Document number: BP-24-09

Title: BPBIO210_220 Renewal Chnage

Design changes have been made to BPBIO210 and BPBIO220 due to the discontinuation of electronic components and quality improvements; the details are as follows.

[Existing Solenoid Valve]

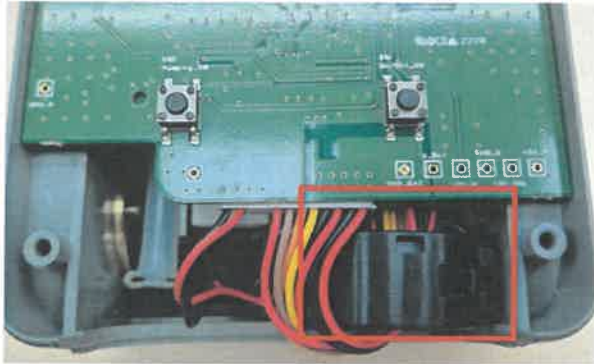
- ① The solenoid valve has been replaced with the one used in BPBIO320/750 for quality improvement.
